# Sheringham Shoal and Dudgeon Offshore Wind Farm Extension Projects

## The Applicant's Comments on Trinity House's Deadline 5 Submission

Document Reference: 21.20

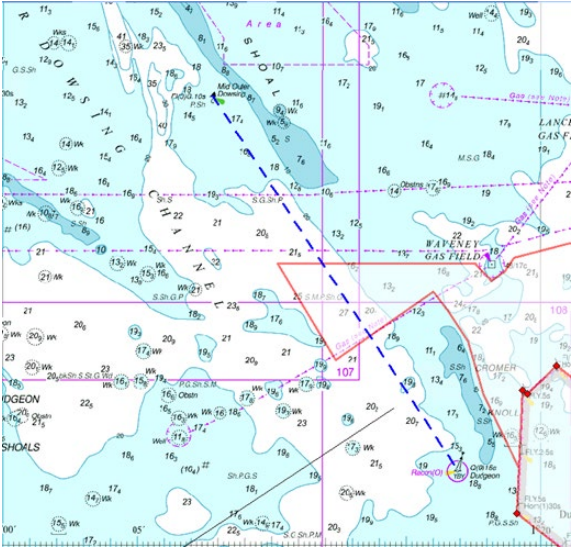
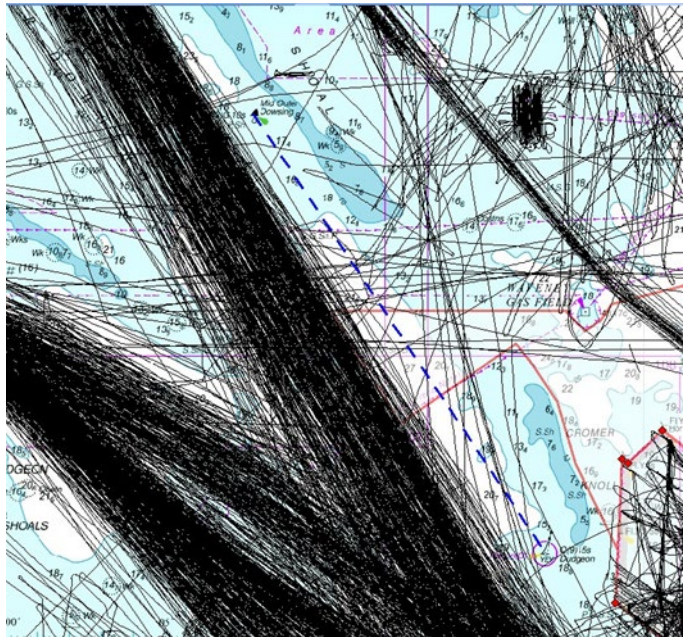
ID	Stakeholder Comment	Applicant's Updated Position at D7
	 <p data-bbox="248 900 846 927">Figure 2 : Overview of area with 28 days AIS traffic</p>	
<p data-bbox="165 951 483 975"><b>2. AIS DATA ANALYSIS</b></p>		
<p data-bbox="165 983 188 1007">5</p>	<p data-bbox="248 983 1106 1134">When assessing our data we generated similar results to the Applicant's, which are reported in the Navigation Risk Assessment [APP-198]. These showed an average of 33 vessels a day passing between the existing windfarms through Gate B shown in figure 3 and 13 a day passing the proposed DEP northwest boundary (Gate A in figure 3).</p> <p data-bbox="248 1150 1048 1238">The traffic patterns show that the majority of traffic passing the DEP boundary is bound between the northerly British ports and mainland European ports as laid out in APP-198 by the Applicant.</p>	<p data-bbox="1173 983 2074 1166">The Applicant agrees that there is broad alignment between the datasets considered by Trinity House and those assessed within the NRA [APP-198]. In particular, the value of 13 vessels per day passing DEP North aligns with the value estimated by the Applicant in the <b>Navigational Safety Technical Note</b> [REP3-031]. As per the response to ID 3, the <b>NRA</b> [APP-198] has considered a large period of data capturing both AIS and non AIS traffic.</p> <p data-bbox="1173 1182 2074 1270">The Applicant also agrees that Figure 4 of Trinity House's Deadline 5 submission [REP5-096] shows an accurate reflection of the western extent of the currently available sea room.</p> <p data-bbox="1173 1286 2074 1374">The Applicant's <b>Navigational Safety Technical Note</b> [REP3-031] provides additional context in relation to how vessels' navigate relative to local navigational features.</p>

ID	Stakeholder Comment	Applicant's Updated Position at D7
	 <p data-bbox="248 882 640 911">Figure 3: Gate analysis positions.</p> <p data-bbox="248 970 1144 1091">The traffic analysis also shows that the majority of the traffic is maintaining a distance of between 0.6nm and 0.8nm clear of a line between the Mid Outer Dowsing Buoy and the Dudgeon Buoy which are Trinity House assets placed to delineate the banks in that area (Figure 4).</p> <p data-bbox="248 1150 1137 1241">Figure 4 also shows that the vast majority of vessels are clearly maintaining a distance of 1.0nm from the shallow patch at the south eastern point of Triton Knoll.</p> <p data-bbox="248 1257 1133 1348">The major shipping appears to be maintaining a distance of 1.0nm from the boundaries of all the windfarms in the area, which aligns with the views expressed by the MCA in its submission [REP1-117].</p>

ID	Stakeholder Comment	Applicant's Updated Position at D7
6	 <p>Figure 4: Buoy to Buoy Line and distances maintained</p>	<p>The Applicant notes that Trinity House calculate the existing sea room as 3.83nm, measured from the controlling depth of 10m on the Triton Knoll bank to the buoy to buoy line on the eastern side and the reduction in sea room is between 0.79nm and 0.84nm assuming full build out of DEP North western boundary (~22%).</p>
<p><b>3. LENGTH OF PERCEIVED CORRIDOR</b></p>		
7	<p>The MCA's position that the corridor should be measured up to the East Dudgeon Buoy [REP1- 117], instead of to the end of the proposed Sheringham Extension, could be the preferred solution when assessing the compression of the traffic given the DEP North Westerly boundary encroaches on the shipping lane. However, in this instance, as can be seen in figures 2 and 3, the traffic appears to already have moved to the sides of the available sea room to progress up the Outer Dowsing Channel or west of Triton Knoll windfarm. Trinity House would suggest that the additional length of the channel when considered in calculations would not bring additional mitigation to this area.</p>	<p>The Applicant agrees, and notes that this particular point is now agreed between the MCA and the Applicant as per the latest <b>draft SOCG with the MCA (Revision B)</b> [REP3-079].</p>
